Subject: AP1000 COL Response to Requests for Additional Information (TR 3)

## Response to Request For Additional Information (RAI)

RAI Response Number: RAI-TR03-015  
Revision: 1

Figure C-1 – FRS Comparison at Base of SCV on CIS at RPV Center

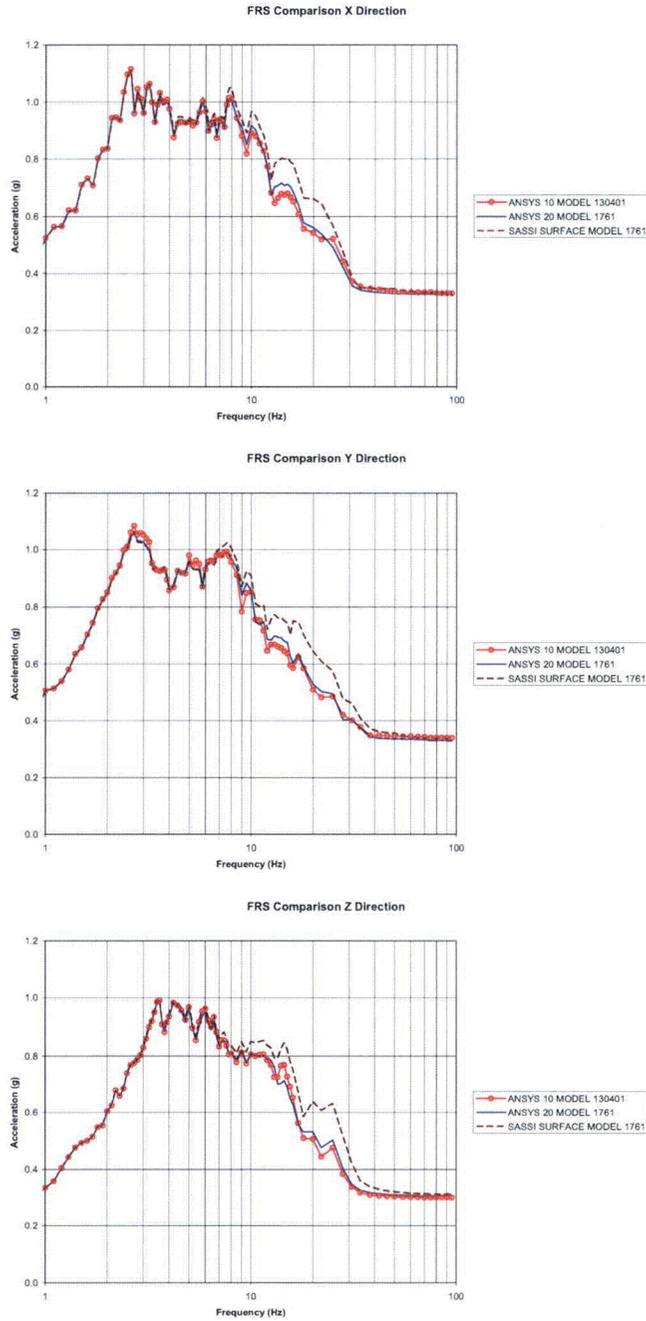
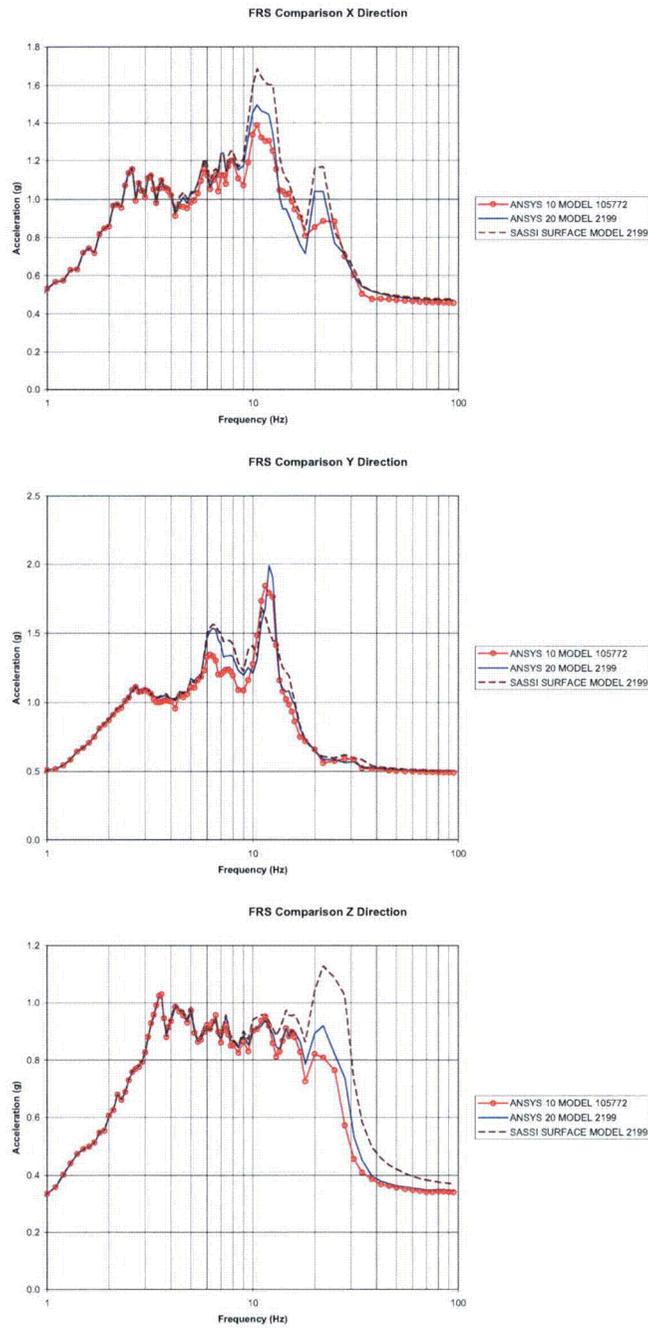
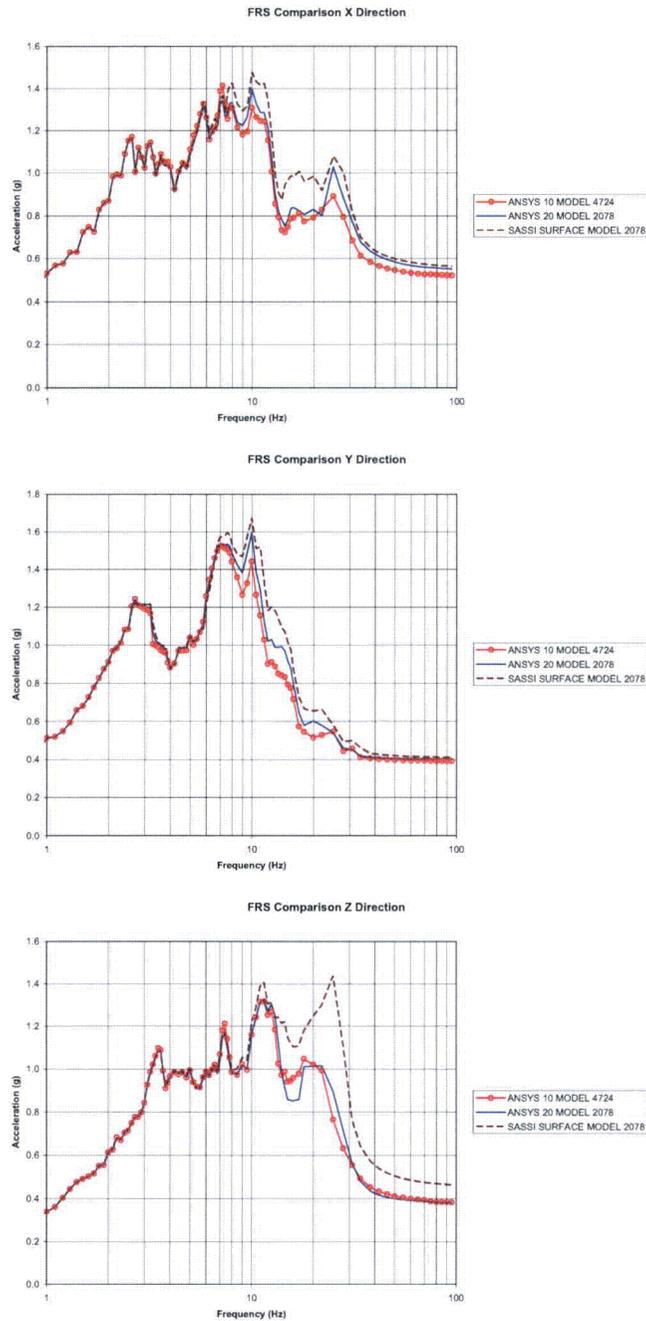
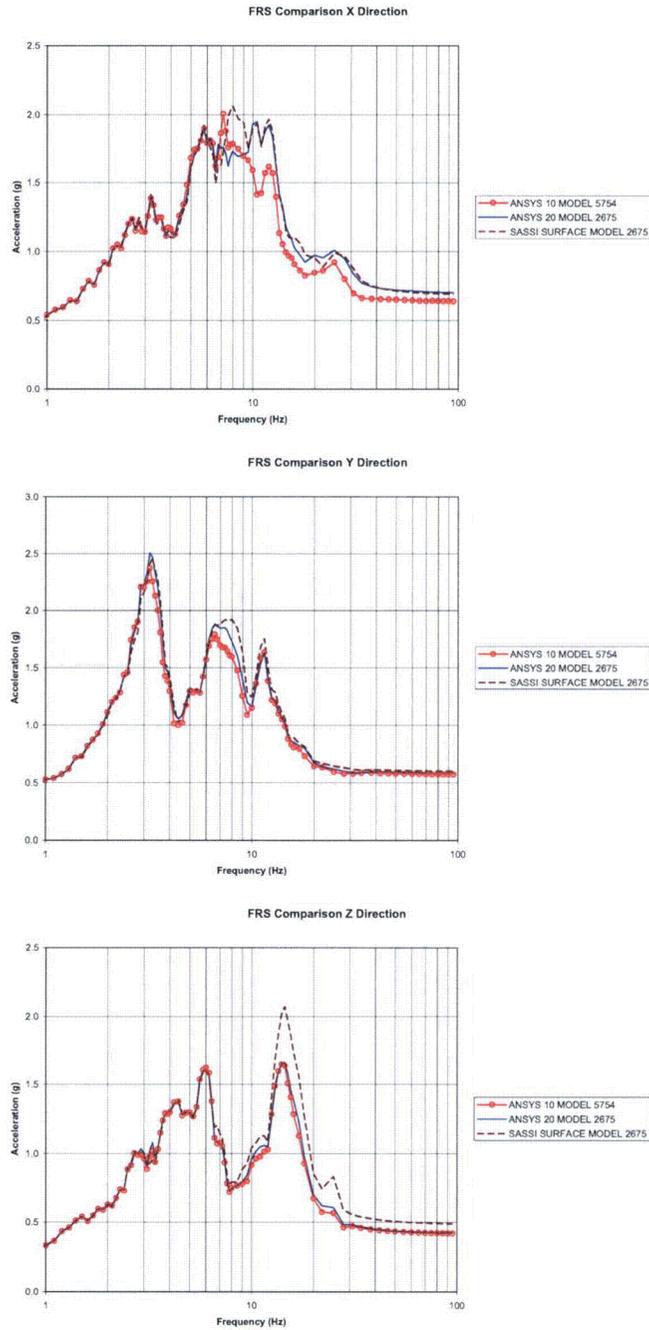
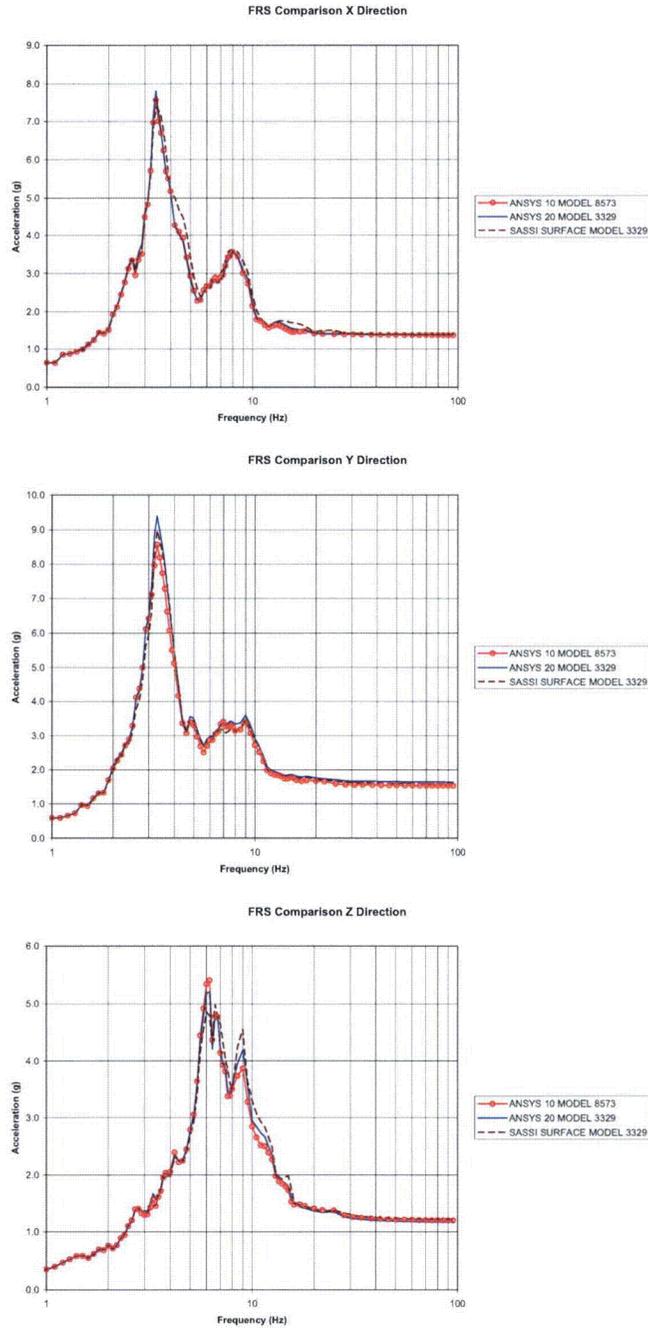
- c. Explain what studies were performed to establish that the NI10 model refinement is sufficient to accurately account for high frequency response effects at all critical locations. It is not obvious from the results shown in Figure C-1 that convergence with element size has been achieved.

The comparisons of the NI10 and NI20 results in Figures C-1 to C-6 show the NI20 model is acceptable for responses above 10 hertz. However, as stated in paragraph 2, the NI10 model gives more accurate results and is used in the fixed base analyses for hard rock. The comparisons of NI10 to NI20 were performed in ANSYS. Analyses have not been performed in SASSI with more refined models than the NI20 model.

Figures C-1 to C-6 compare response spectra for ANSYS analyses of the NI10 and NI20 models at the interface seismic response key nodes (see Section 4.4.3). These locations are given in Table C-1. Also shown in this table are the figures where the comparison spectra are given. Both finite element models give comparable results below 10 hertz. However, the results from the coarse model are not as good at high frequencies (above about 15 hertz). Therefore the hard rock FRS were generated from the fine NI10 model, and the coarse NI20 model was used for the soil site analyses where frequencies of interest are below 10 hertz.

As seen from the comparison (see Figures C-1 to C-6), for the horizontal response, the SASSI and ANSYS results for NI20 are very similar to about 15 Hz horizontal and about 10 Hz vertical. At the higher frequencies SASSI calculates higher accelerations. The NI20 model uses solid elements for the mass concrete below grade inside the shield building. Other parts of the model use shell elements. The difference in ANSYS and SASSI results is most noticeable at the three
